AEOD TECHNICAL REVIEW REPORT *

UNIT: San Onofre 1
DOCKET NO.: 50-206
LICENSEE: Southern California Edison
NSSS/AE: Westinghouse/Bechtel

TR REPORT NO.: AEOD/T333
DATE: October 31, 1983
EVALUATOR/CONTACT: Harold Ornstein

SUBJECT: DEGRADATION OF SALT WATER COOLING SYSTEM - CAUSED BY A LOSS OF INSTRUMENT AIR

Figure 1 Salt water cooling system.

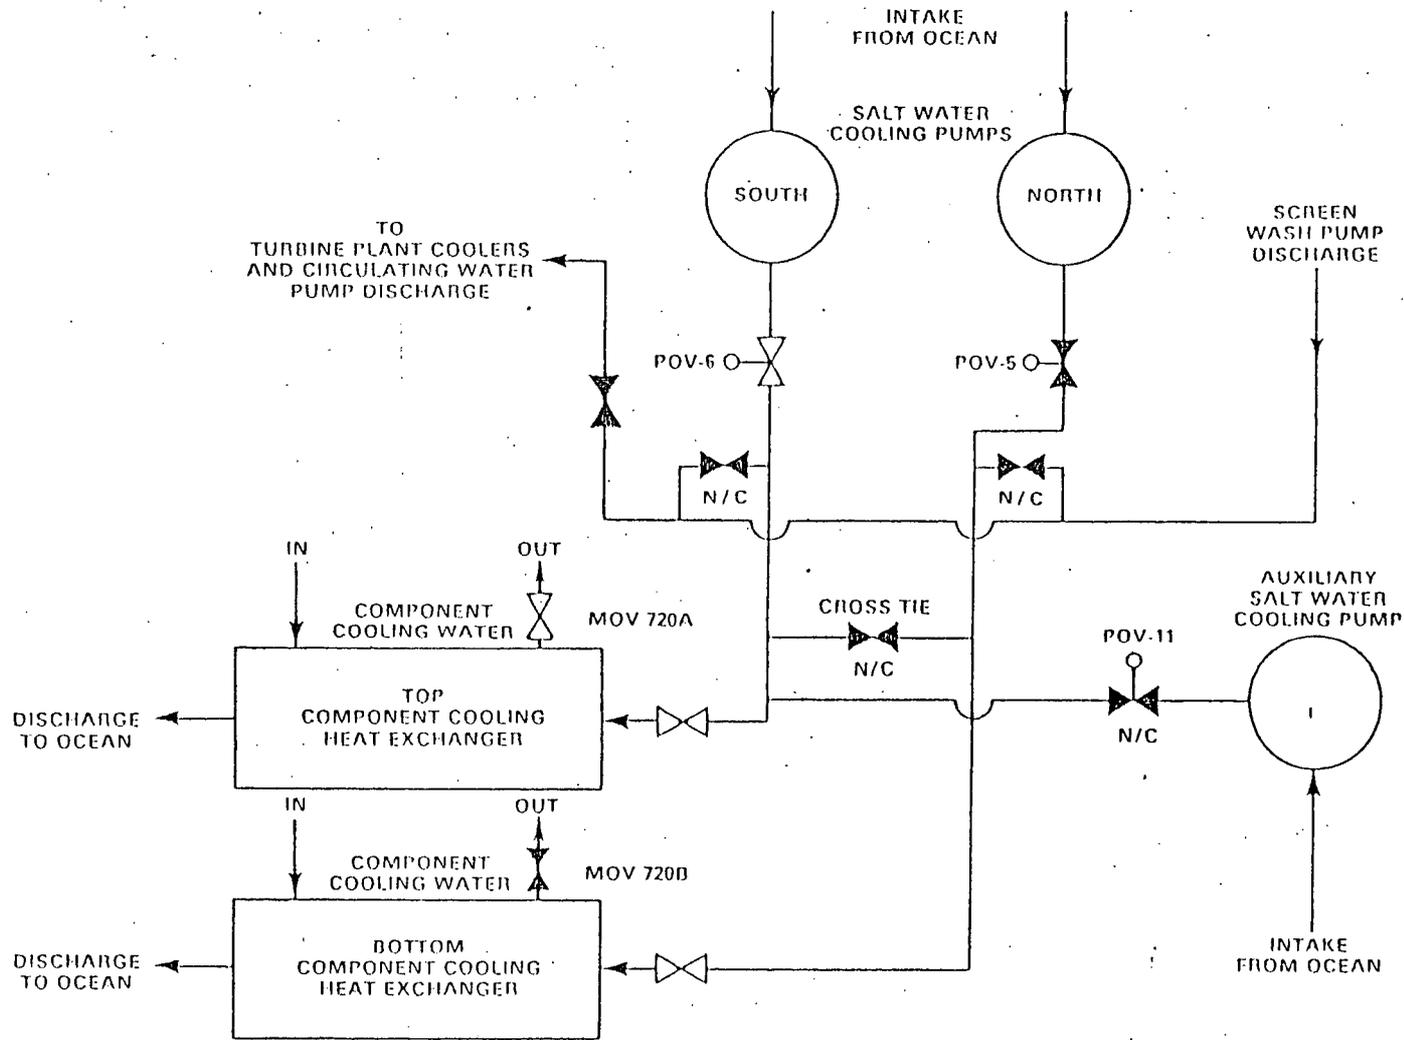
The SWC pumps' discharge valves are designed to fail in place upon loss of air (see Figure 1). Since the south SWC pump was operating, when the air was lost, the south SWC pump's discharge valve remained open and that train continued to function normally. The north SWC pump was off when the air was lost. Therefore its discharge valve remained closed upon the loss of air. There is a backup nitrogen accumulator on the south SWC pump discharge valve; however, the licensee was uncertain of the accumulator's capability of closing the valve had closure been required. (It was known that the discharge valve could be opened with accumulator nitrogen upon loss of instrument air; however, the licensee was not sure that the discharge valve could be closed under such conditions). As shown in Figure 1, in order to assure proper system operation and preclude backflow through the idle train the discharge valve on the idle SWC pump must be closed if the cross-tie valve is open or if the auxiliary SWC pump is in operation. Similarly, the auxiliary SWC pump had an air operated discharge valve without an accumulator; the loss of air rendered that valve inoperable. In essence, the loss of instrument air degraded the multi-train SWC system to a single train system.

1. Install check valves in the SWC pump discharge lines.
2. Lock open the existing SWC pump discharge valves.
3. Provide nitrogen accumulators for all POV's in the system.

Temporarily install new air operators and solenoid valves on the discharge lines.

It should be noted that these modifications would preclude degradation of the SWC system in the event of a future loss of instrument air.
